NUREG-1368

Preapplication Safety Evaluation Report for the Power Reactor Innovative Small Module (PRISM) Liquid-Metal Reactor

Final Report

U.S. Nuclear Regulatory Commission

Figure 5.13 Alternative flow model for blockage of RVACS inlets.

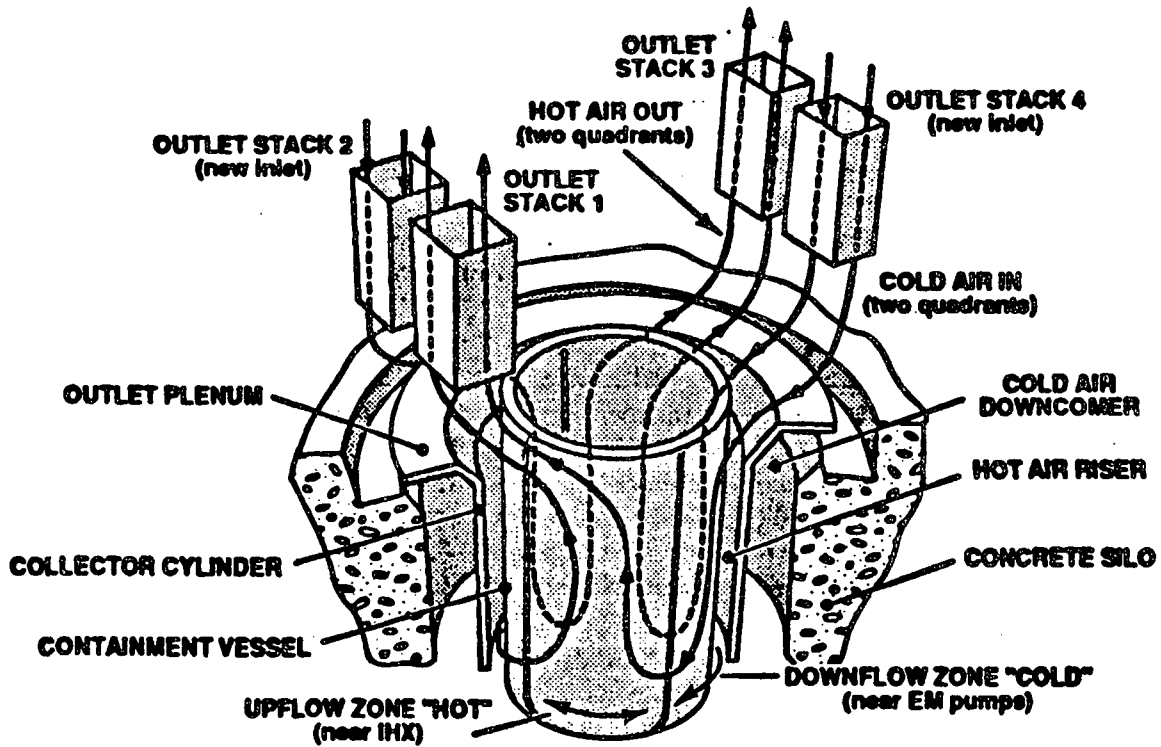
For a blockage of just the inlets, an alternative method of heat transfer becomes important. This method is shown in Figure 5.13. In this case, two of the four outlets would become inlets. Air would still circulate by natural convection; however, air would circulate downward near the cool sodium of the EM pumps, and would rise near the hotter sodium of the IHX. Hence, the two outlets near the EM pumps would become inlets, and the outlets near the IHXs would remain outlets. The designer has stated that maximum temperature at the core outlet would reach 904 K (1168 °F), below Level C limits, and that uncertainties in the analysis might increase this temperature

Figure 15.4 PRISM reactor changes to enhance accident mitigation capability

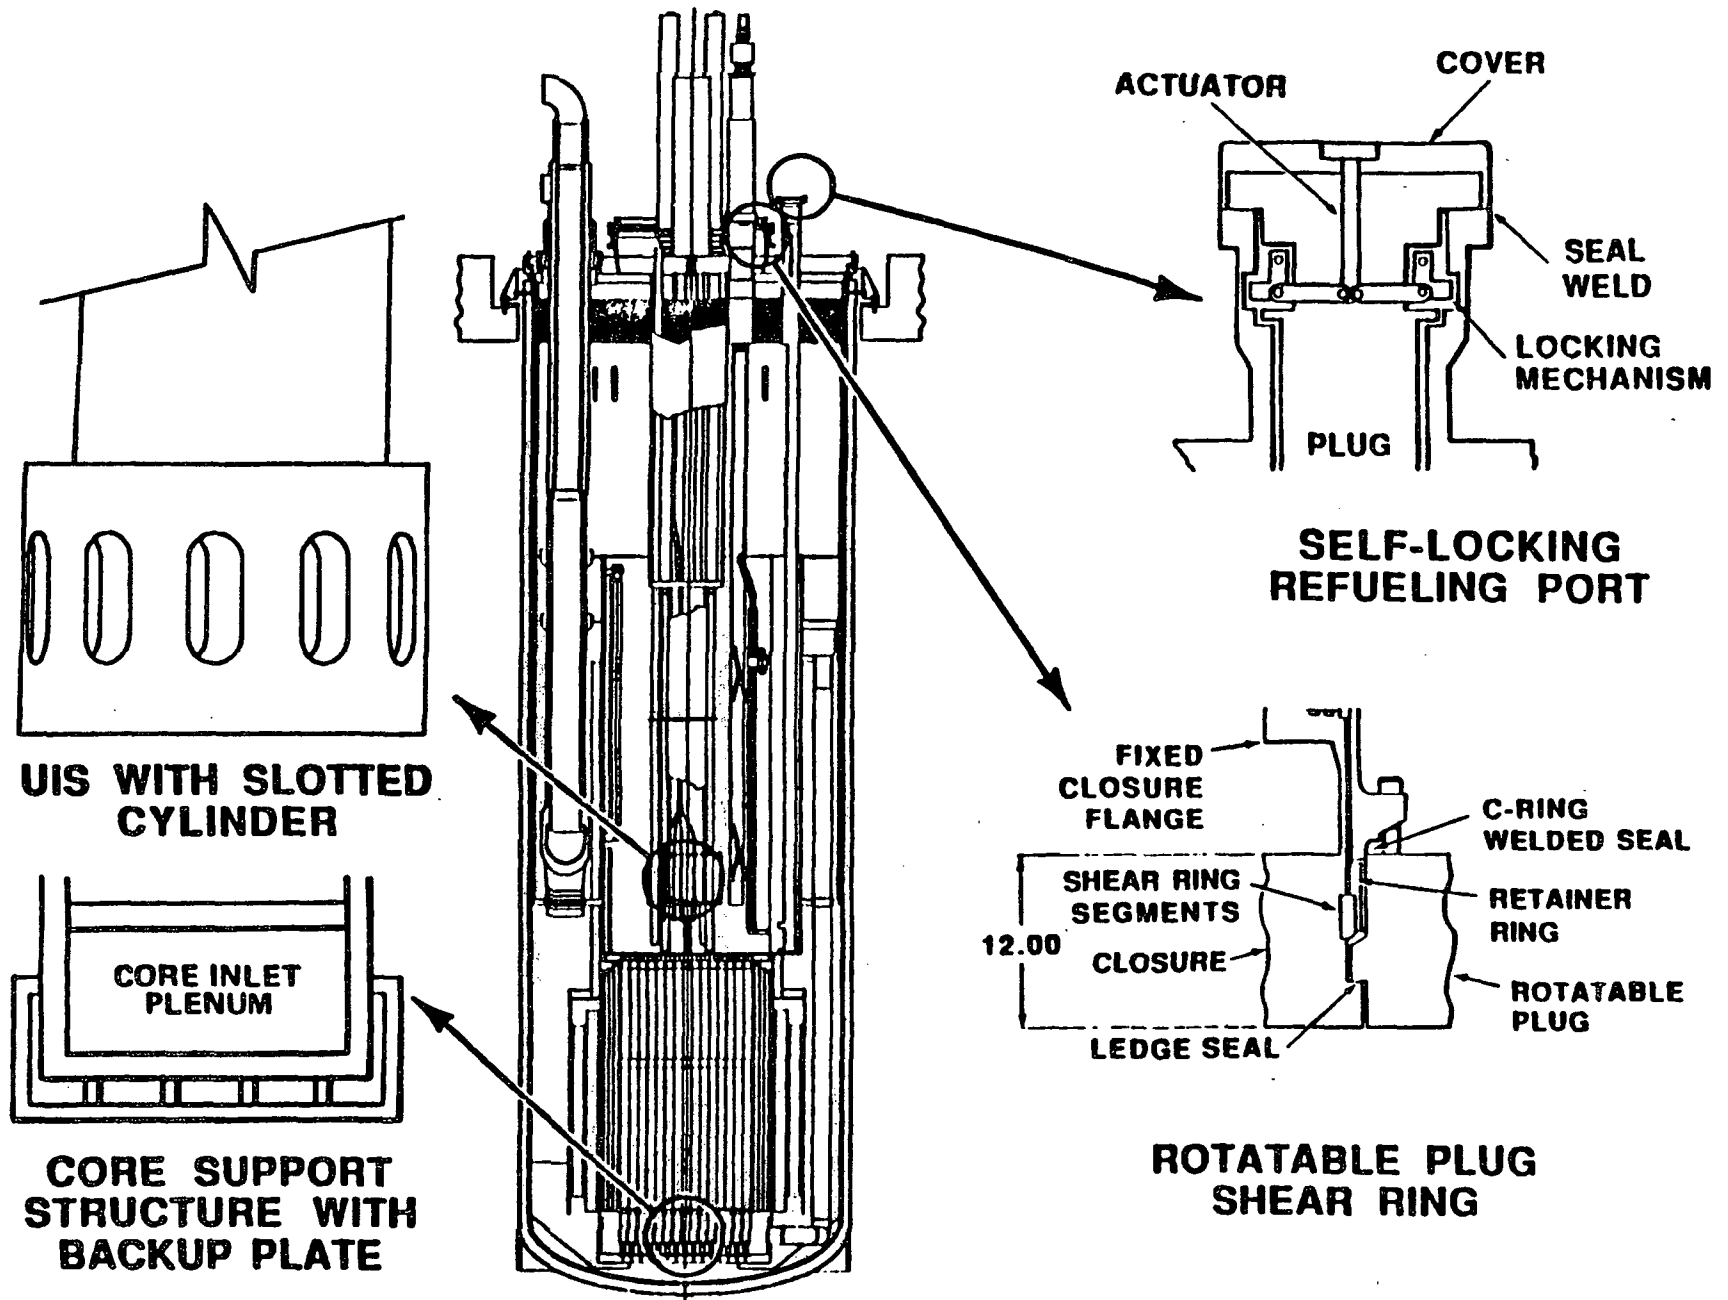
Several design changes are now under consideration to enhance the ability of the reactor to contain the consequences of an HCDA and/or a core melt accident within the primary system boundary. Several specific hardware features, to address HCDA energetics and core melt, under consideration, shown in Figure 15.4, are:

Figure B.2 Summary of GE Bounding Events 1A, 1B, 2', and 4

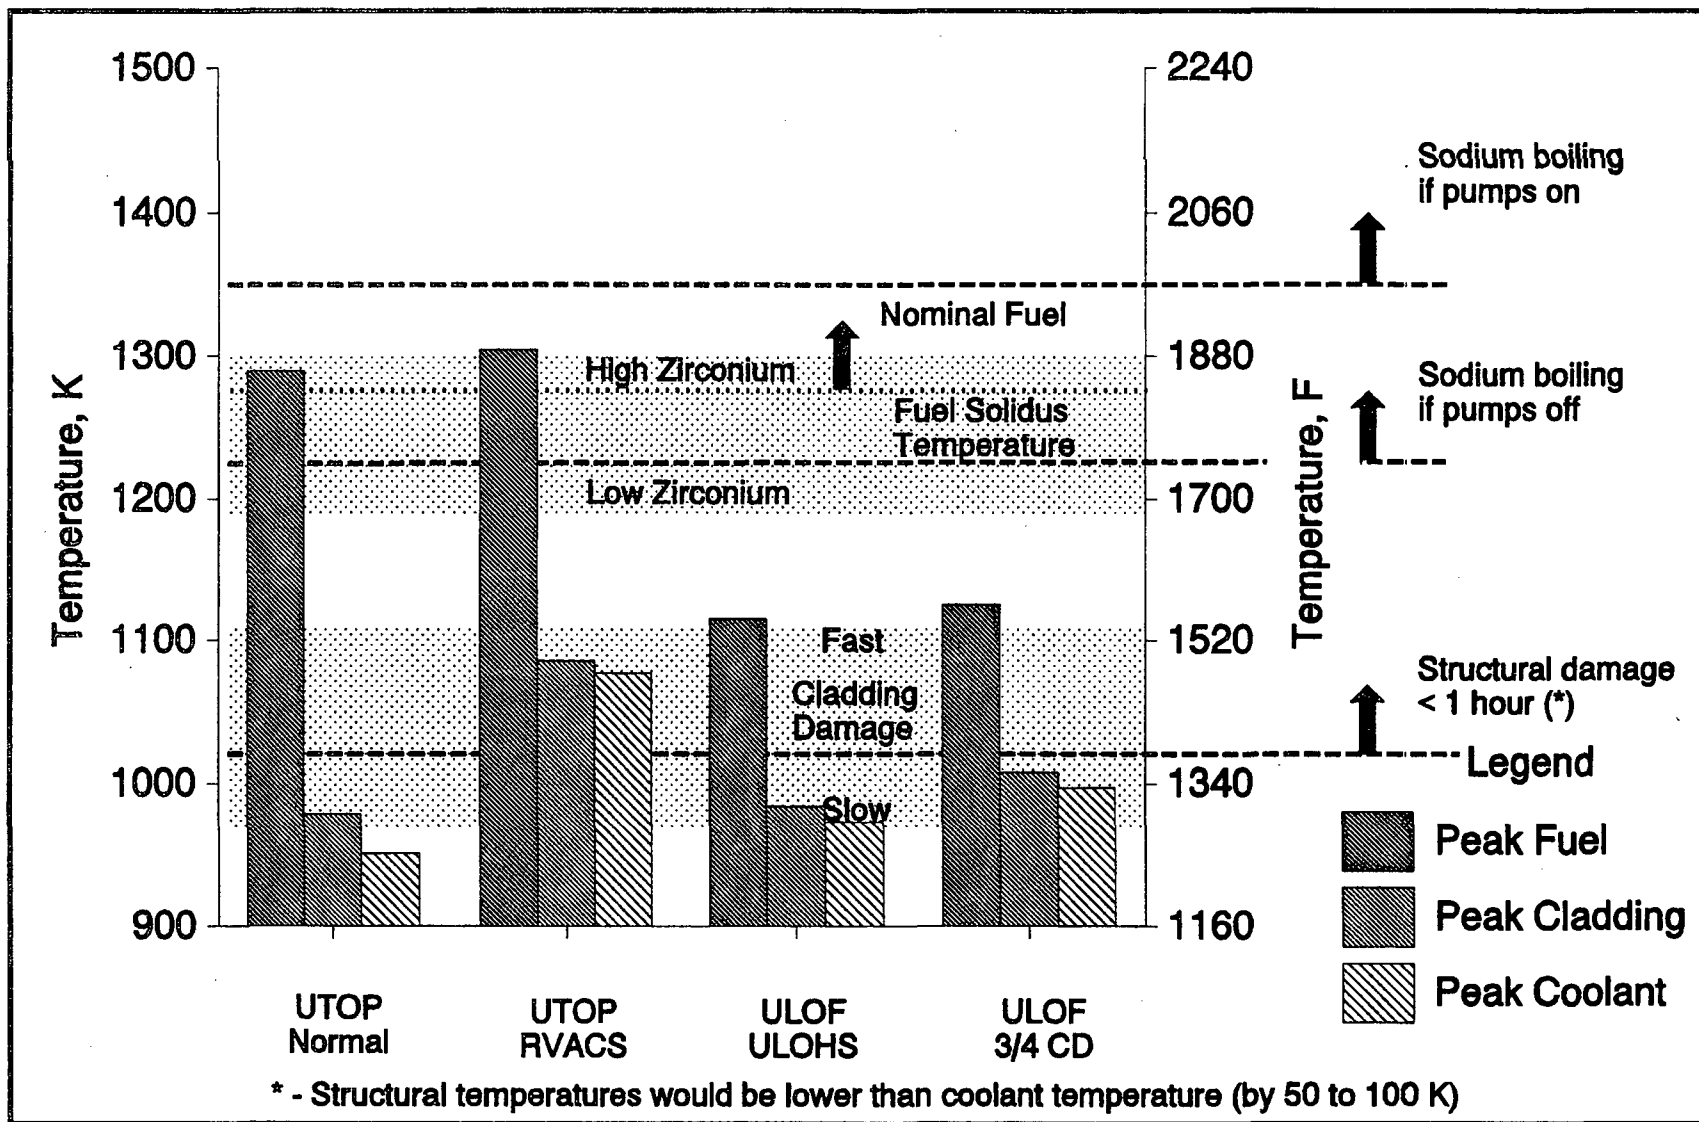
It is clear from Figure B.2 that some fuel would be heated above the solidus temperature for BE-1A and -1B. For the UTOP events, the power production in the pins increases by about 70 percent, so the pin center-line temperatures can increase very substantially. As the peak fuel temperatures for BE-1A and BE-1B are above the solidus temperature for the zirconium fuel, there is little doubt that some localized melting would take place. A decision will be required at the design certification stage, in terms of how much, if any, localized fuel melting will be acceptable.

The ULOF-ULOHS (BE-2') and ULOF-3/4 coastdown (BE-4) events on the right side of Figure B.2 result in significantly lower fuel temperatures. There may be a very slight amount of cladding damage for these events, especially if conservative limits are applied. The sodium is well below boiling, with or without pumping. A major factor in limiting the peak temperatures is the use of the GEMs to insert a large amount of negative reactivity once the pumps trip off line.

The GE results presented in PSID Section G.4.16.2, as summarized in Figure B.2 point directly to the postulated UTOP events as the safety concerns within the category of "bounding events." Independent analyses performed at Brookhaven National Laboratory (BNL) (Ref. B.5) tend to confirm this, although BNL's peak fuel temperatures are somewhat higher, and the subsequent cladding damage greater. Despite ANL's optimism that it can demonstrate that metal fuel can survive these events, GE may have to consider reducing the potential UTOP initiator below 40¢ (including uncertainties), perhaps by moving the control rod stops more frequently. Because the preapplicant seems to have a few options available to reduce the potential UTOP initiators, the results summarized in Figure B.2 are not viewed as an insurmountable problem.
